# MATANUSKA-SUSITNA BOROUGH

## **PLATTING BOARD AGENDA** **ASSEMBLY CHAMBERS** **350 E DAHLIA AVENUE PALMER**

**June 1, 2023**

**STAFF REVIEW AND RECOMMENDATIONS  
PUBLIC HEARING  
JUNE 1, 2023**

### A PLAT OF HULL FAMILY HOMESTEAD

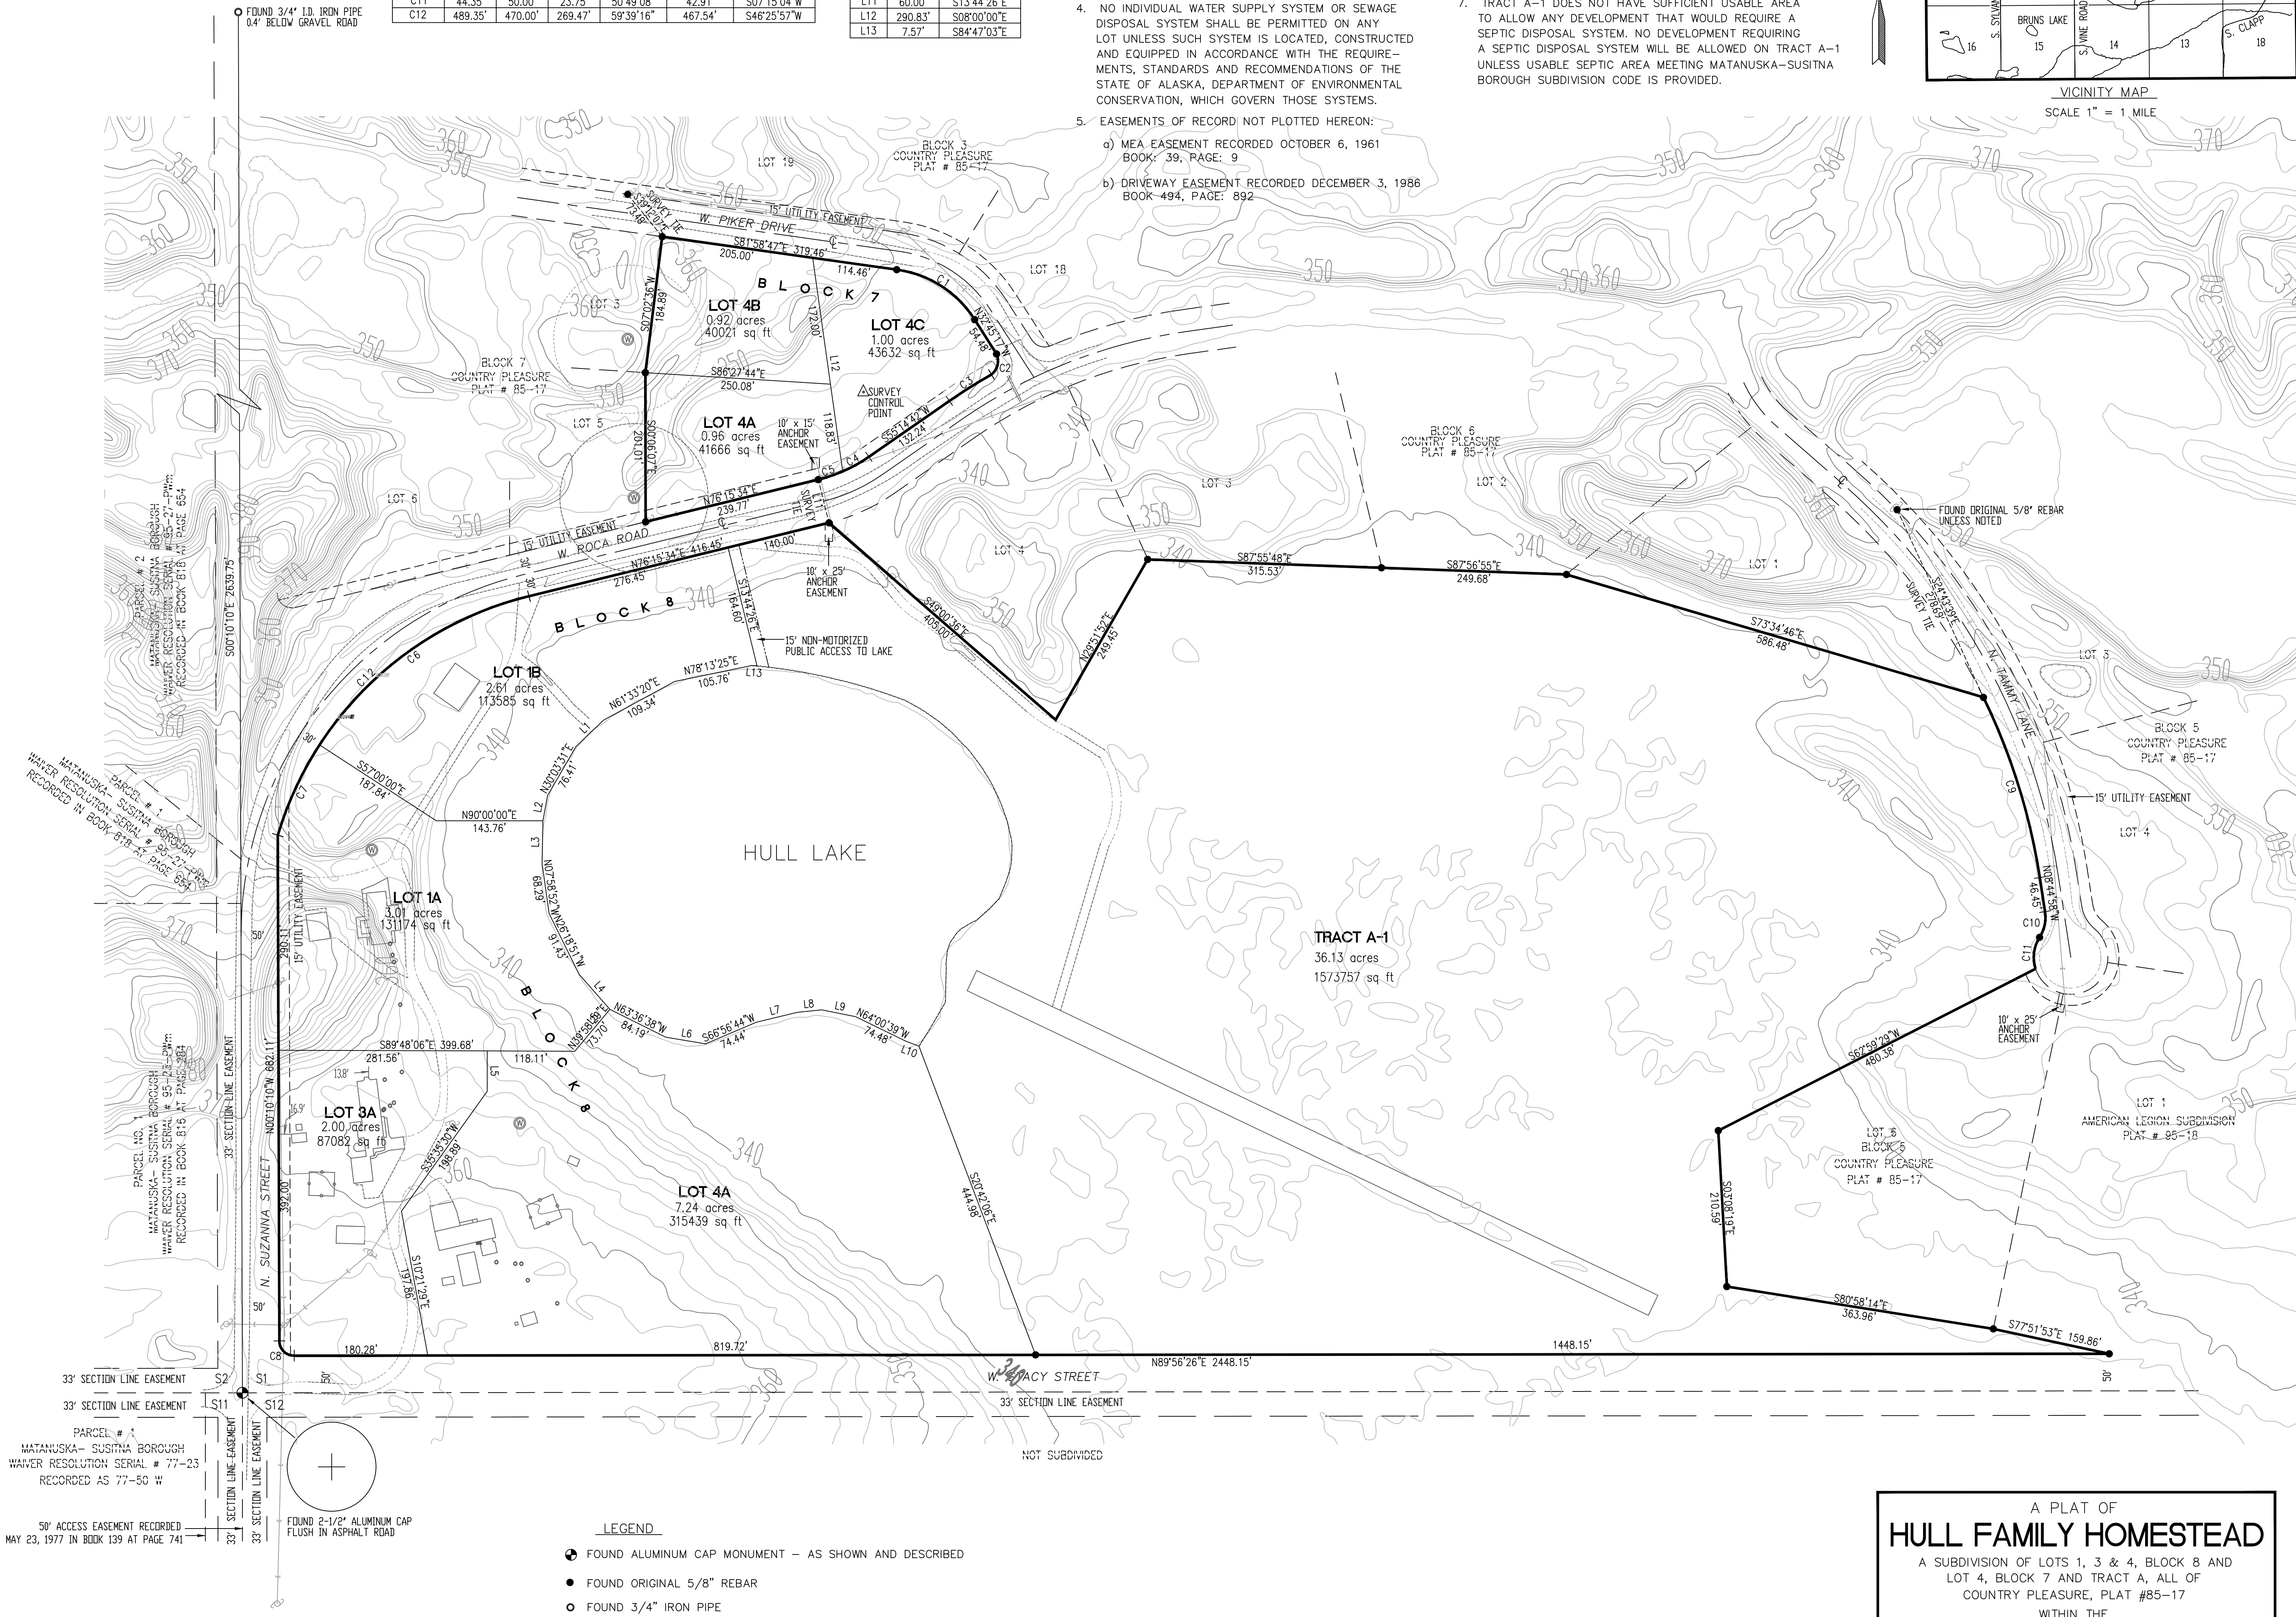
Since Suzanna Street and Roca Road are collector roads, per SCM A04.3 (B), applicant needs to calculate average access point spacing and (D) show the proposed access points on the preliminary plat.

EXHIBIT C - 7

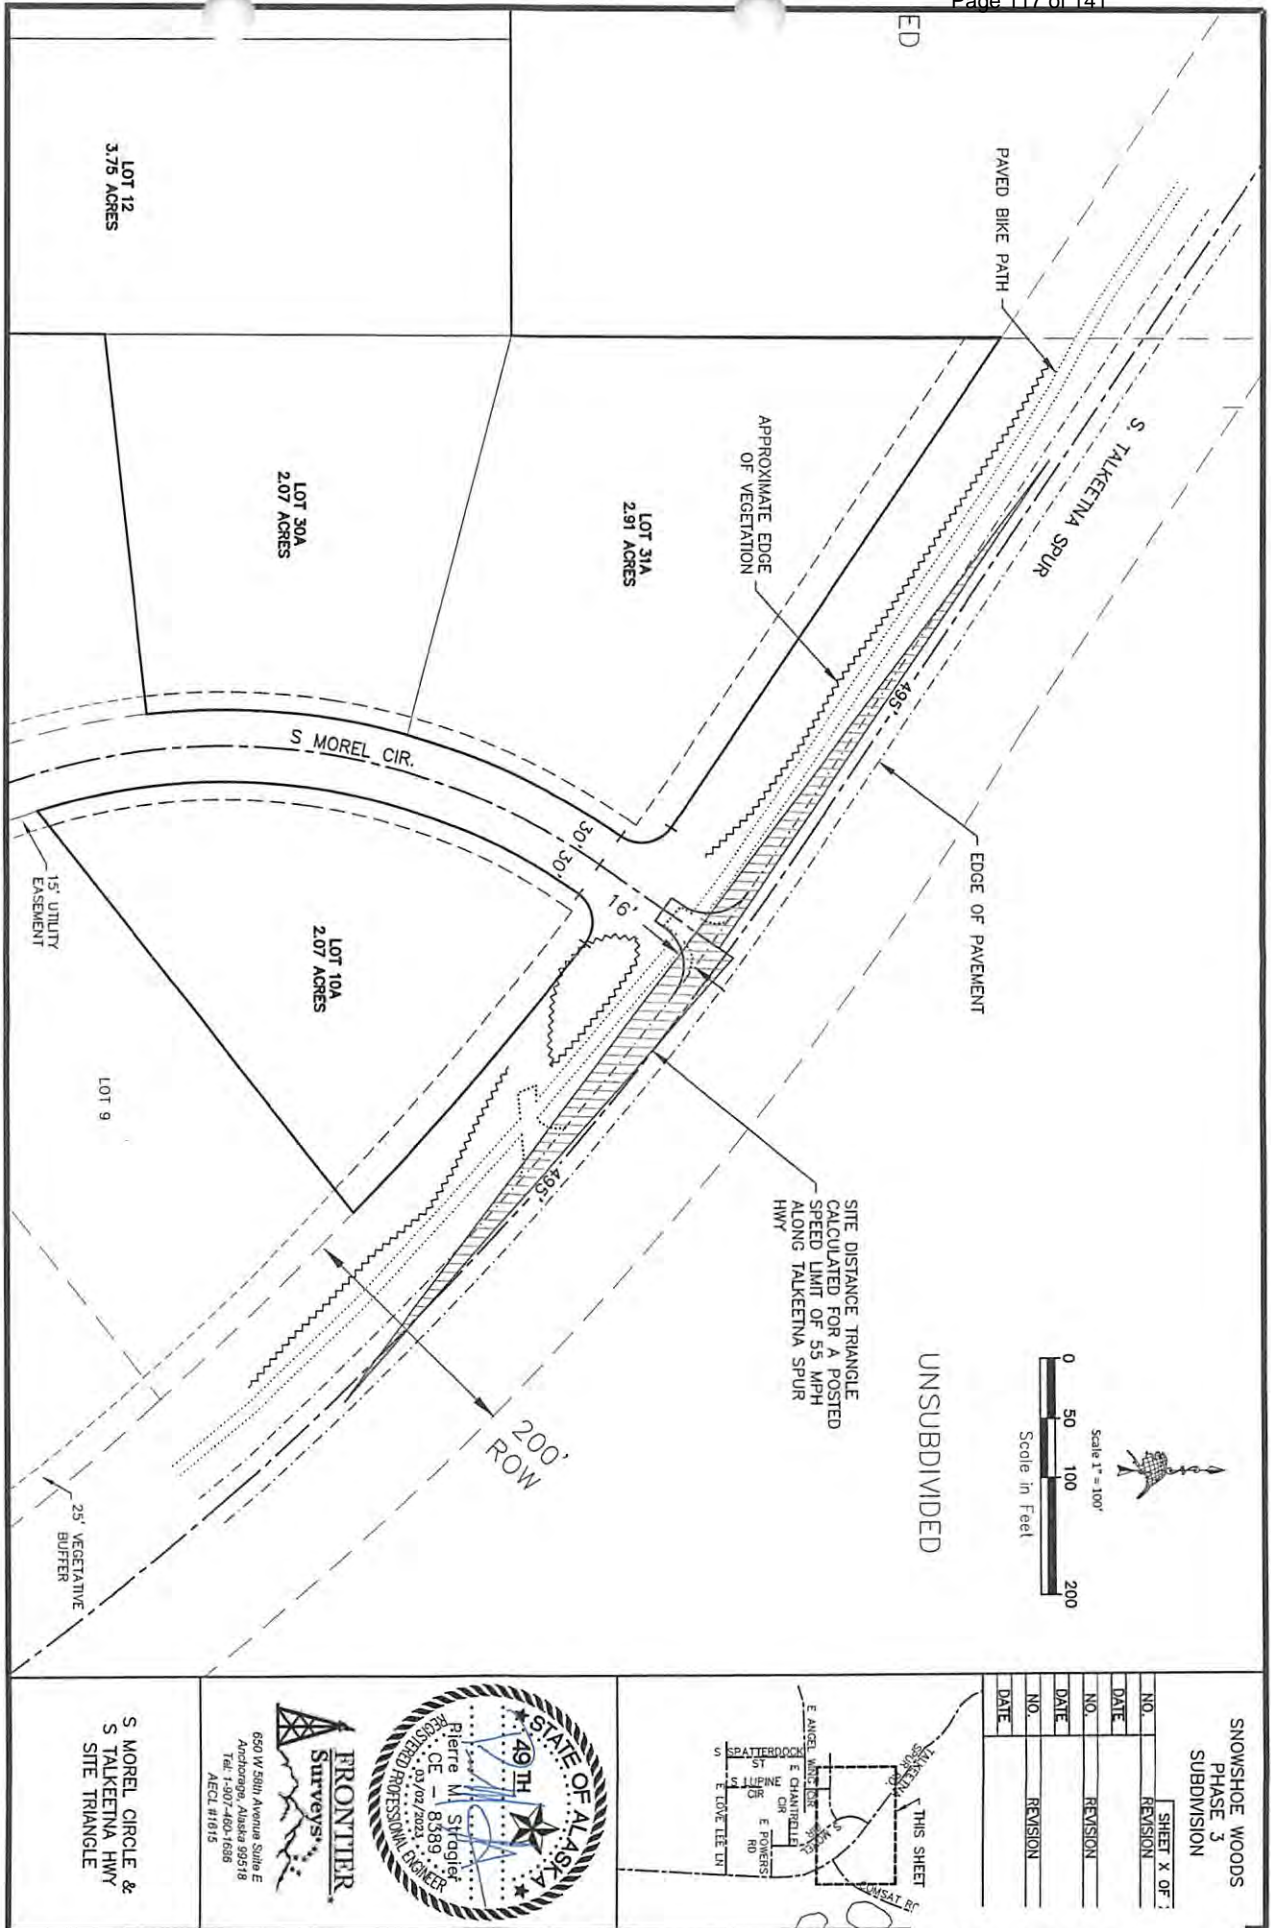
- It appears an old version of the drainage report was submitted. Frontier submitted a revised drainage report on 9/9/2022, attached, which reflected PD&E's comments on the catchment area boundaries. However, that drainage report should be further revised now to include the extension of Morel Circle.
